Town of Brookfield
645 N. Janacek Road
Brookfield, WI 53045
(P) 262-796-3788
(F) 262-796-0339

Architectural Review Committee

TOWN OF BROOKFIELD
ARCHITECTURAL REVIEW COMMITTEE MINUTES
JULY 9, 2025

TO: Town of Brookfield Architectural Review Committee
FROM: Rebekah Leto, AICP, Town Planner
MEETING DATE: August 13, 2025
RE: **August 13, 2025 agenda items**

SOUTH ELEVATION

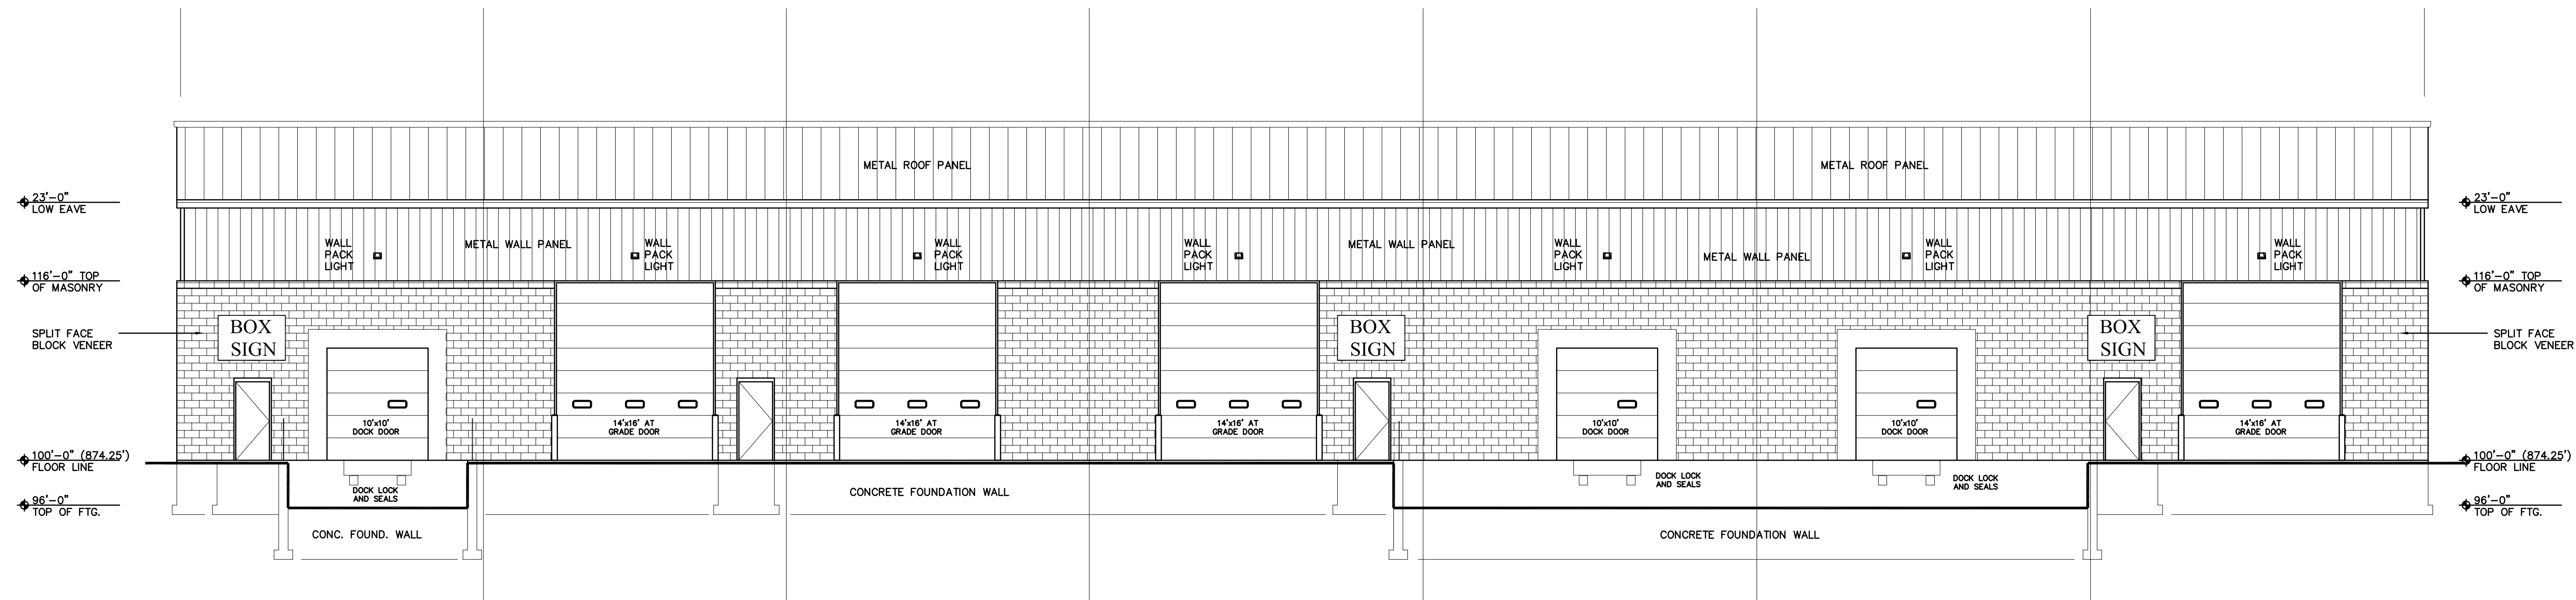
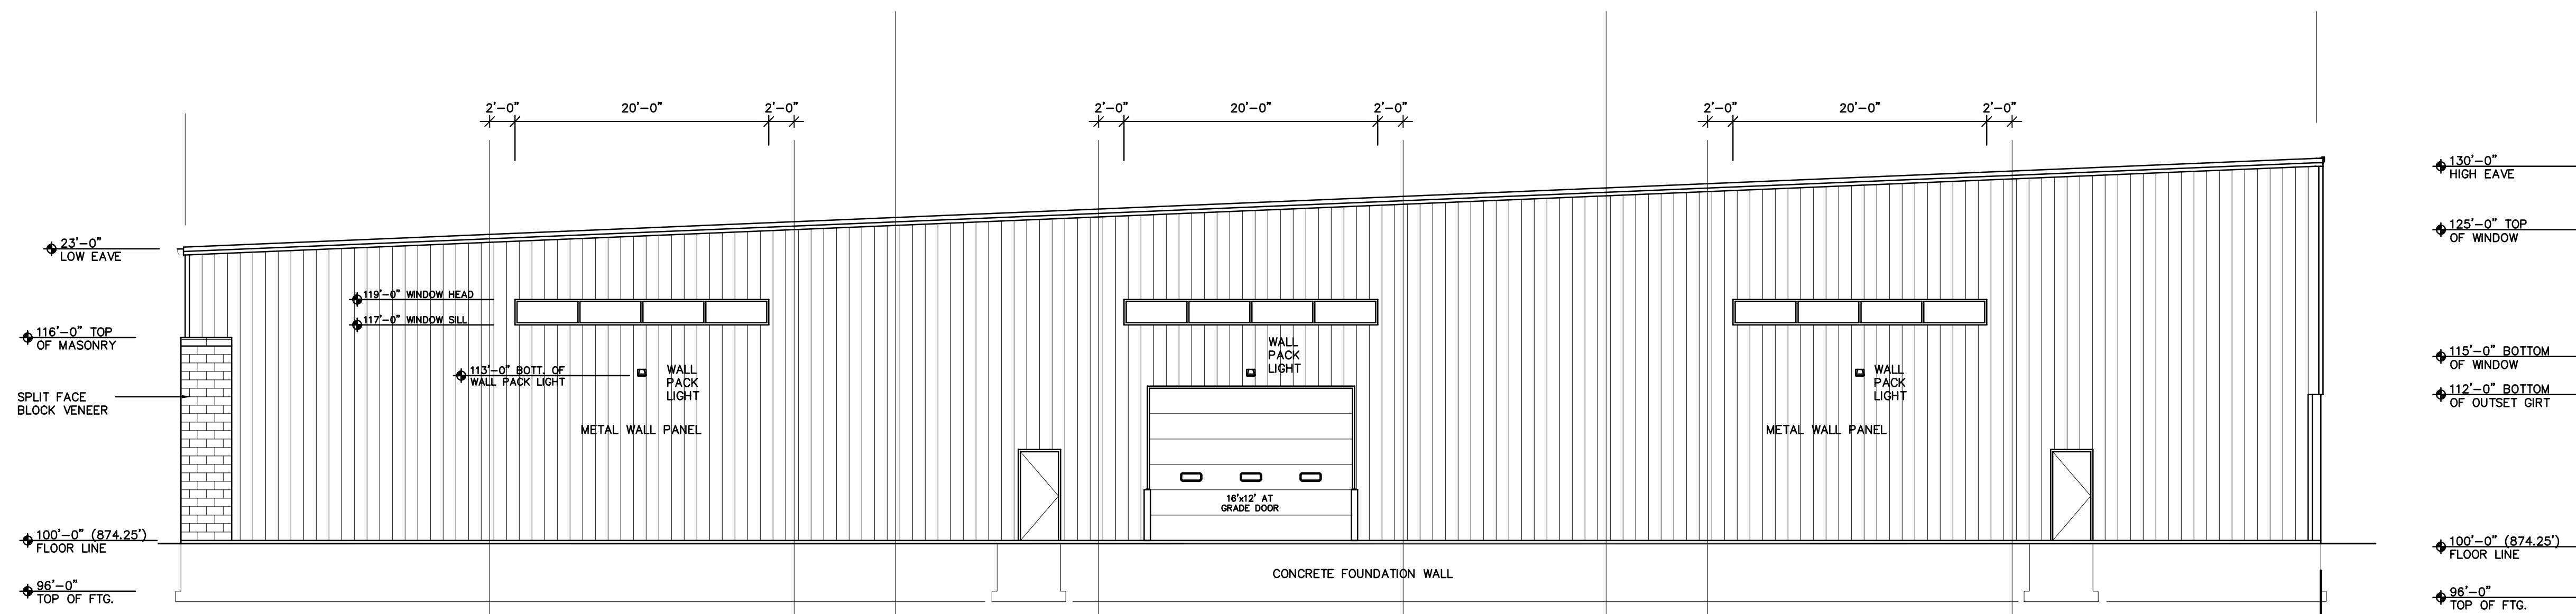
On July 9, 2025, the ARC approved the wall signs on the south elevation as shown on Exhibit A submitted at the meeting, which showed the wall signs being centered over/above the 2nd, 4th and 6th windows along the front of the building. The ARC also requested that a Master Sign Program (MSP) be prepared, which has been submitted for review. The ARC did not approve the cabinet signs on the north side of the building, as presented, noting the amount of white was significant for the size of the sign. The applicant has submitted a revised plan showing a significantly larger logo on each 15 sq. ft. sign, as well as a phone number and storeroom address. The signs will still be internally lit and will be centered over each service door. The MSP memorializes the square footage for each space and the building overall, which will accommodate the larger logo and name of Good Health Saunas in the center unit. It also identifies standards for continuity of the signs and notes that each tenant must obtain ARC approval.

NEW MONUMENT - JUNE 2025

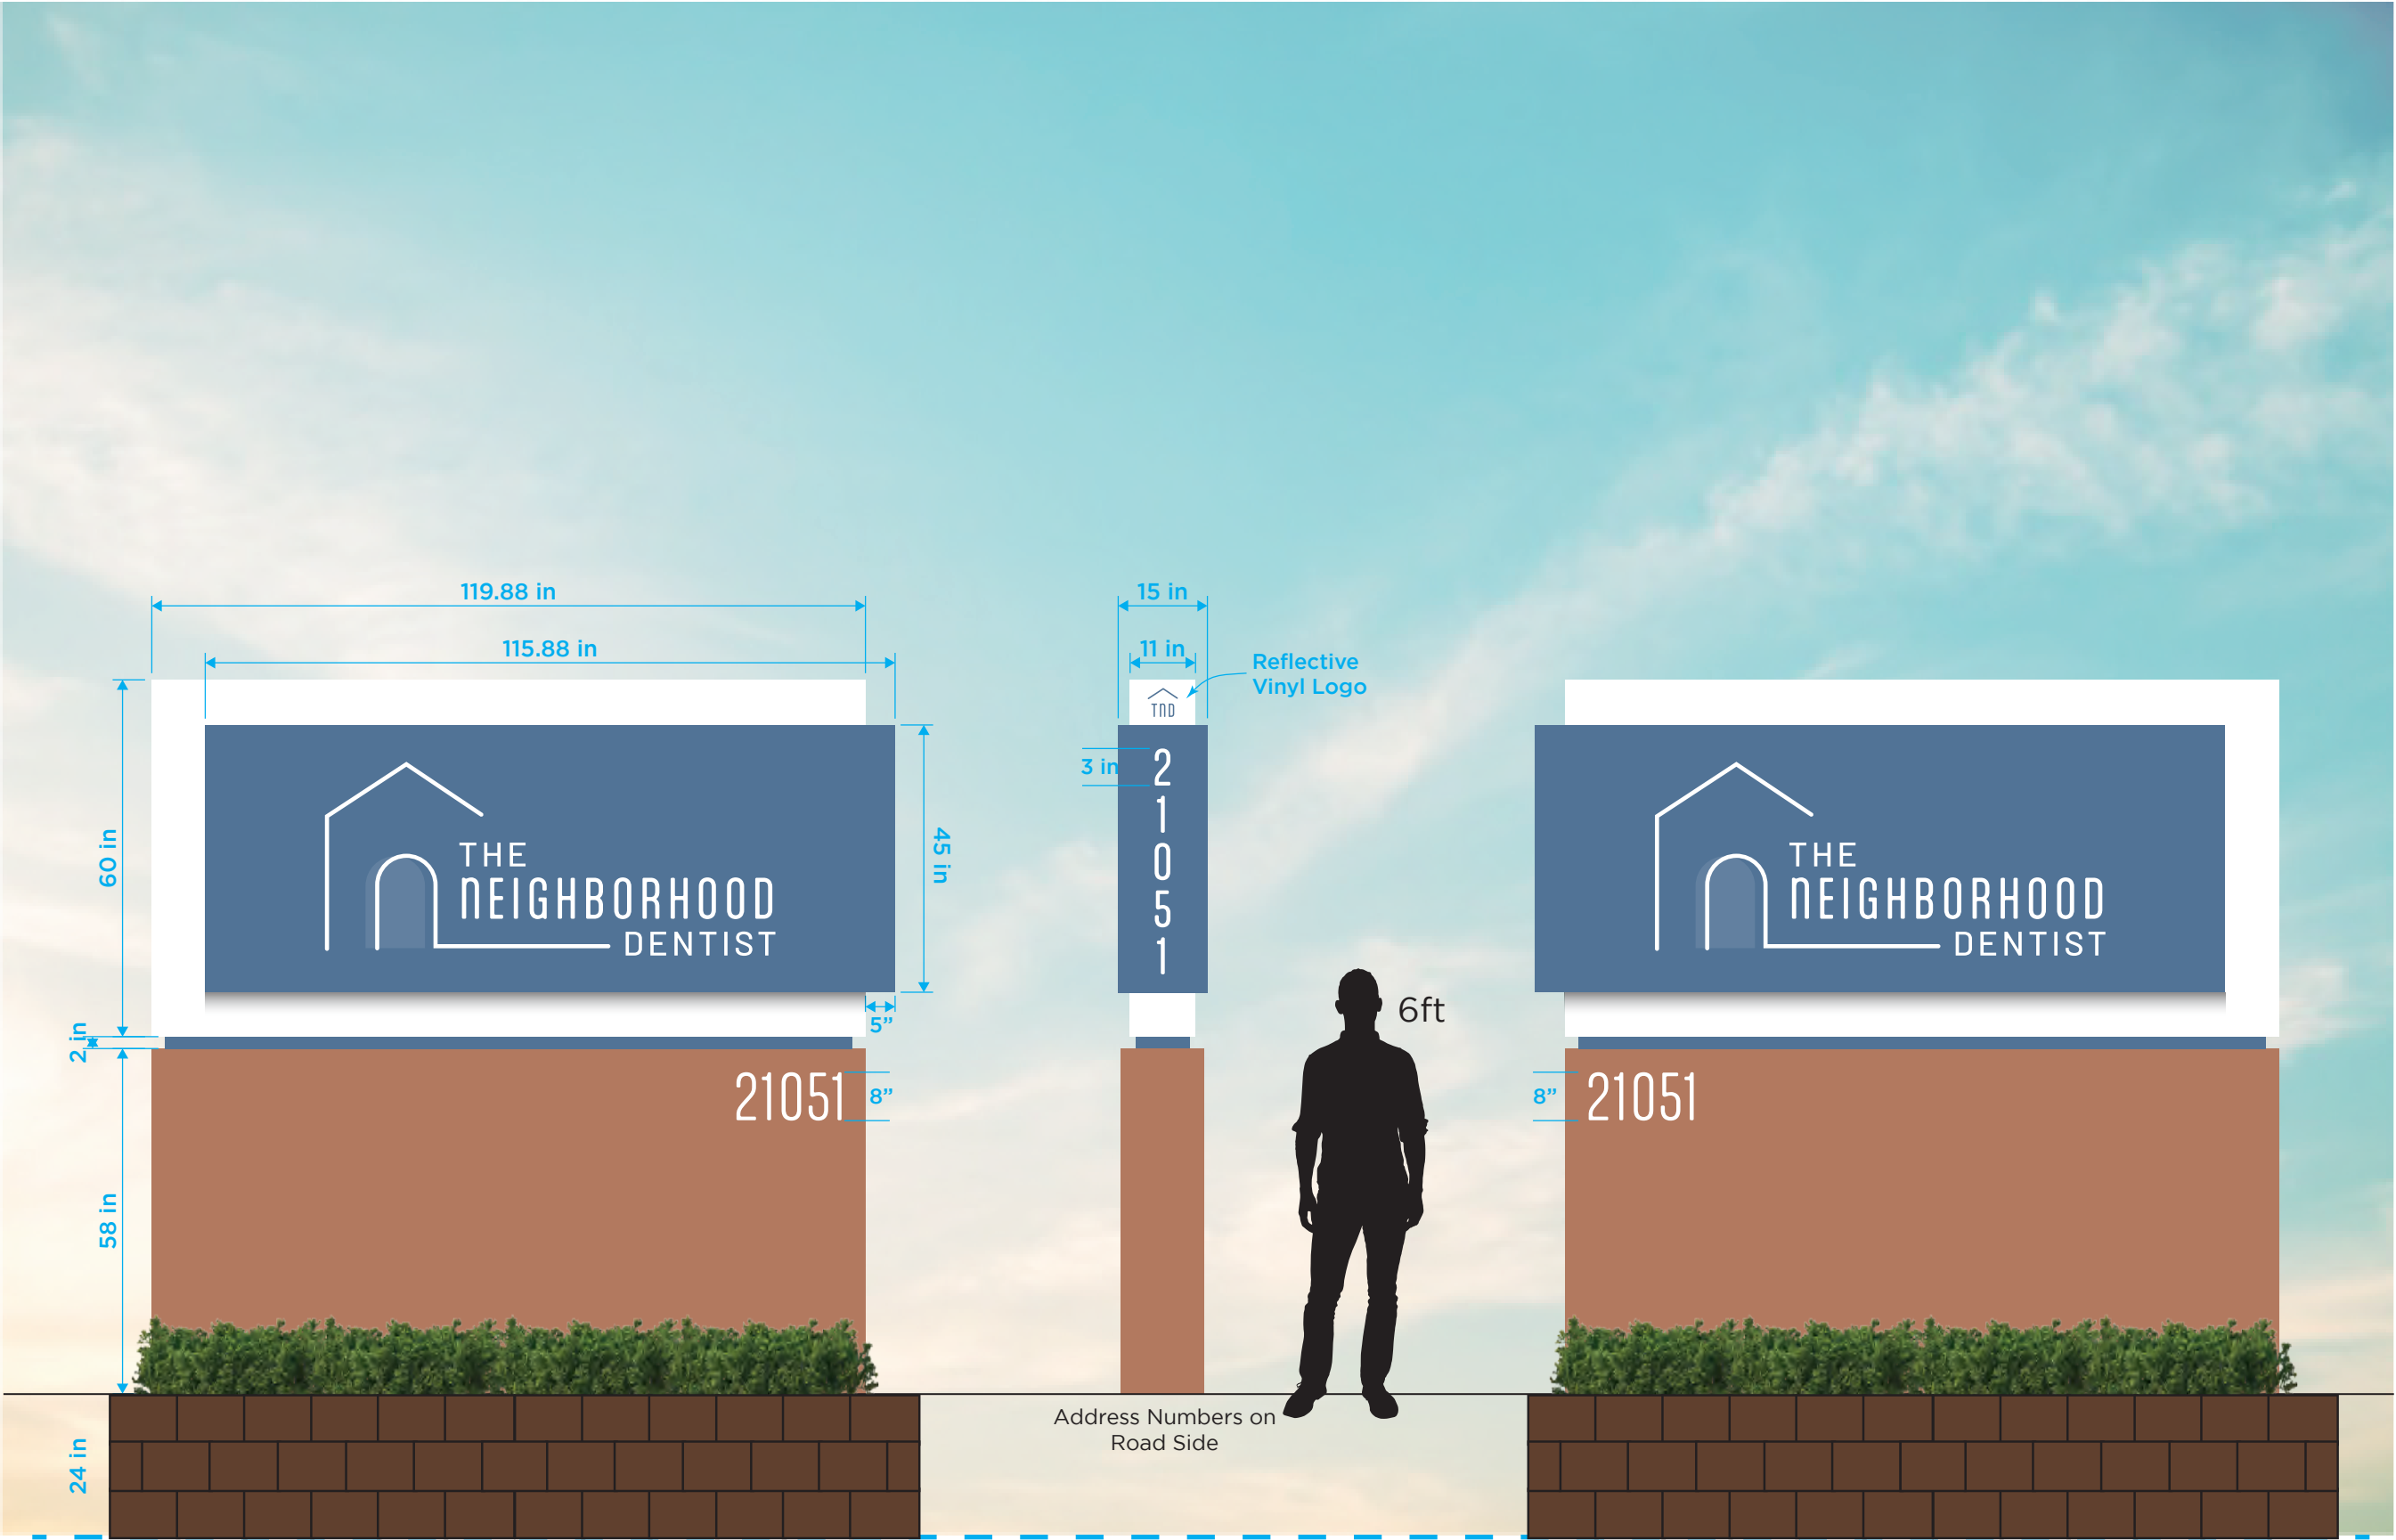
The Neighborhood Dentist has an existing freestanding sign in the southeast corner of the property. The owner is proposing to remove the existing sign and replace in the same location. The sign meets the road setback requirements. The sign will be placed on a 2 ft. raised landscape bed. The base is 5 ft. tall by 10 ft. wide, with the actual sign also being approximately 5 ft. by 10 ft. The maximum display area permitted is 70 sq. ft. per side. Address numerals are located on the base. The white letters and address numerals are LED-backlit. The proposal complies with the Code.

P:\3250112\Drawg\Sheets\3250112-T01.dwg, FIRE TRUCK ACCESS PLAN, 7/23/2025 9:16:08 AM, CBW

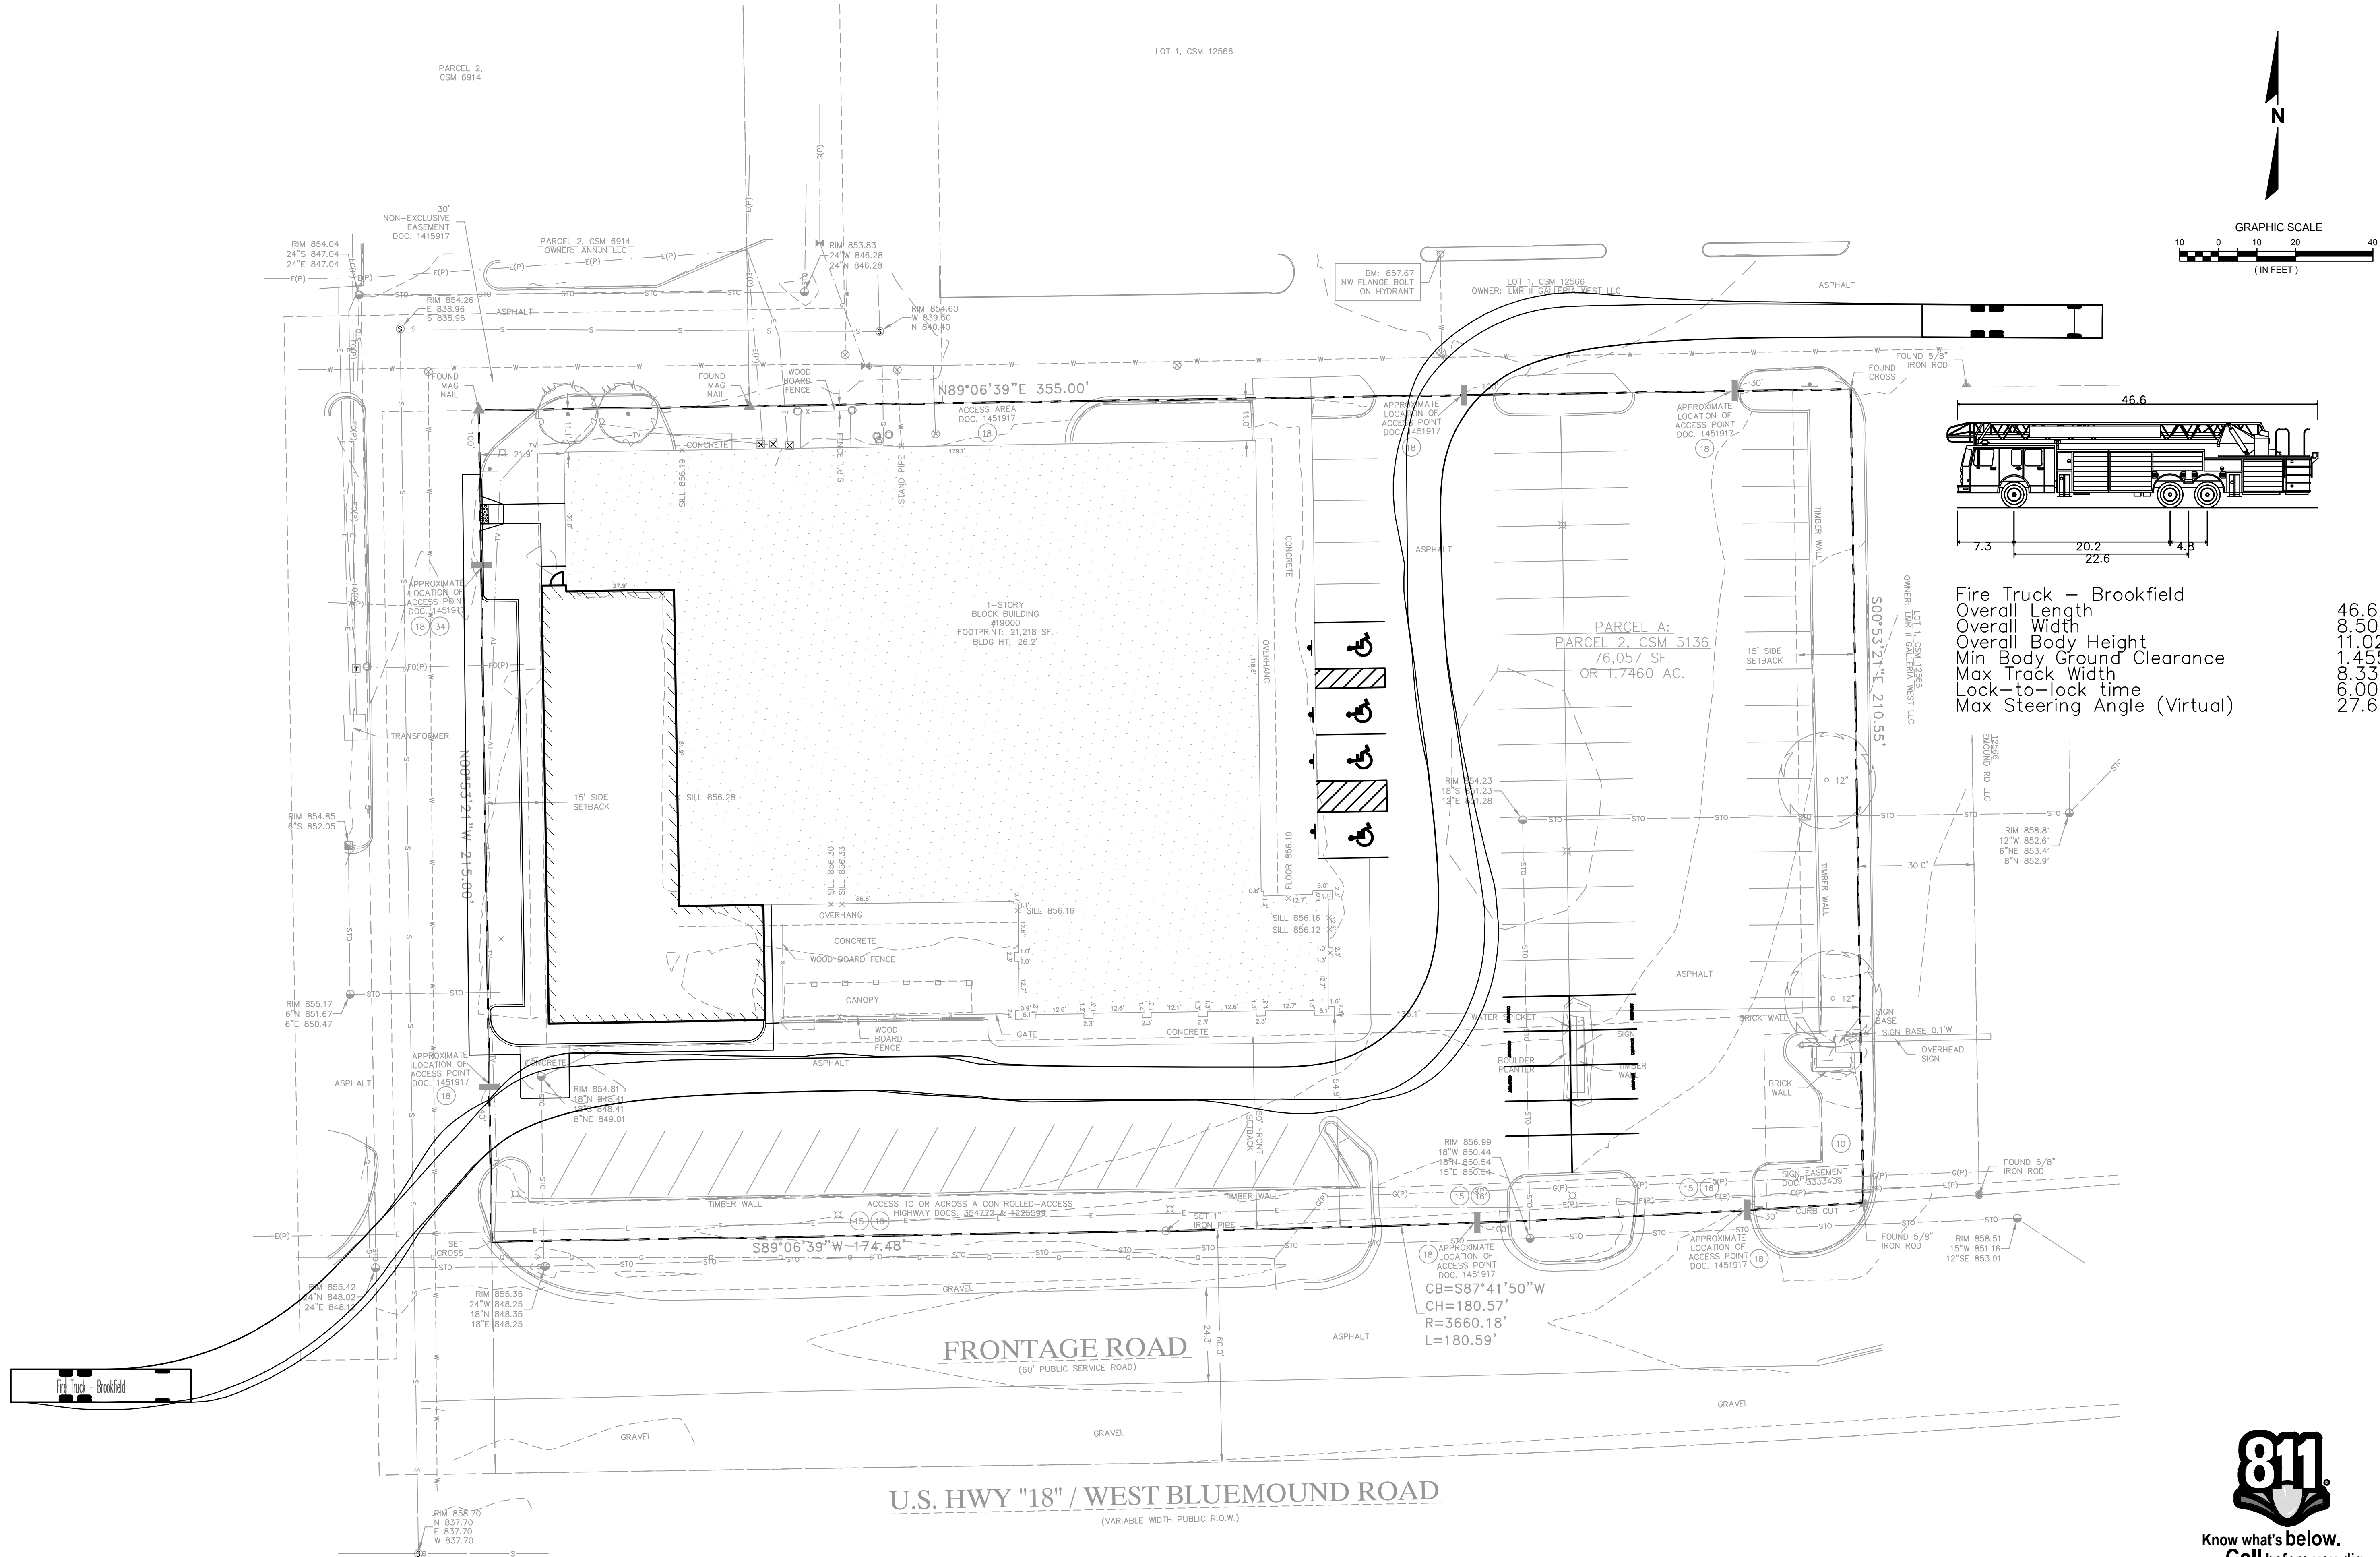
Ingress/Egress: The northwest entrance to the site will be removed. A fire truck access plan is included in the civil packet (C201).
